Arboricultural Letter of Reply

**Multi-Purpose School Hall
Kingswood High School
131 Bringelly Rd Kingswood
NSW 2747**

20 February 2019

Ref: NASR GROUP PTY LTD – Kingswood High School Multi-Purpose School Hall

Figure 2. Excerpt from DA Landscape Plan, 175.19(18)/512, Issue 08.02.19, iScape Landscape Architecture, February 2019

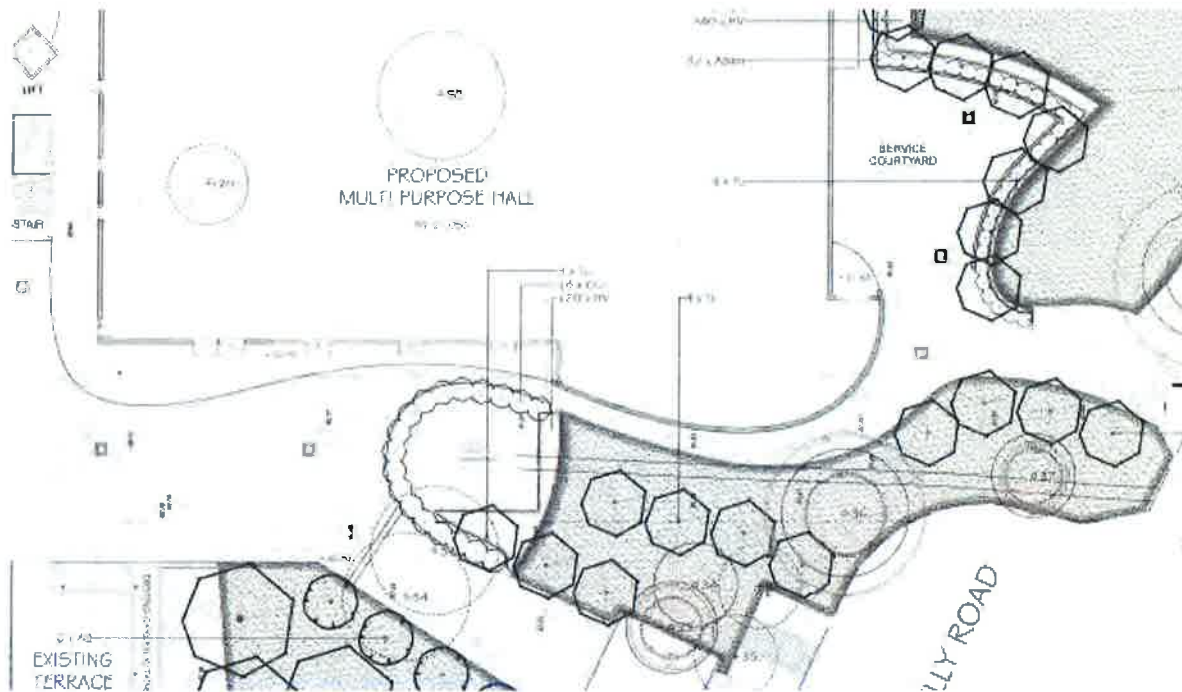
- 5.2.1 Review of the proposed design has been undertaken in the context of tree retention and removal across the site.
- 5.2.2 Tree 21 has a major encroachment of 24.9% into its total TPZ area. This encroachment is required to facilitate the re-alignment of the existing palisade fence and increase of the existing footpath area. While the fence post uprights may be placed following root sensitive excavation methods, the concrete footpath construction will intrude into the SRZ. This tree will therefore require removal to facilitate the development.

- 5.2.3 Tree 53 has a major encroachment into its TPZ. This tree would require removal to facilitate the development. Landscape plans propose the loss of all trees on site is offset with thirty-nine (39) replacement trees.

- 5.2.4 Tree 36 has a minor encroachment of 8.7% into its TPZ provided no over excavation for kerb edging or stormwater is required to facilitate the new driveway. In this instance the tree can be retained with little or no effect on tree health or stability considered likely, providing sensitive construction measures are adhered to during construction.

- 5.2.5 Tree 41 has a minor encroachment of 9.2% into its TPZ provided no over excavation for kerb edging or stormwater is required to facilitate the driveway entry. In this instance the tree can be retained with little or no effect on tree health or stability considered likely, providing sensitive construction measures are adhered to during construction.

- 5.3.1 Trees 21, 23, 33, 36, 37, 41, 42, 43, 44, 45, and 85 will have both minor and major encroachments into their TPZ's for landscape and refurbishment works.
- 5.3.2 The iScape landscape specification plan suggests excavation of between 150mm to 350mm depth, including deep ripping of excavated base, below existing grade for the installation of turf and mass planted areas. This cannot occur as significant tree roots will be severed and/or damaged.

- 5.3.3 All landscape items must therefore be installed above extant grade within the TPZ of all trees to be retained. Any additional fill should be of a largely sand composition to allow the infiltration of water and air to roots below.
- 5.3.4 During the construction process and prior to landscaping, all trees to be retained should be protected in accordance with Section 6.4 of this document. Following, fencing can be removed to allow landscaping to occur.
- 5.3.5 In order to minimise the potential damage to roots of trees to be retained during mass planting, holes within TPZ's of these trees are to be hand dug. Maximum pot size of plants within these zones should not exceed 200mm diameter.
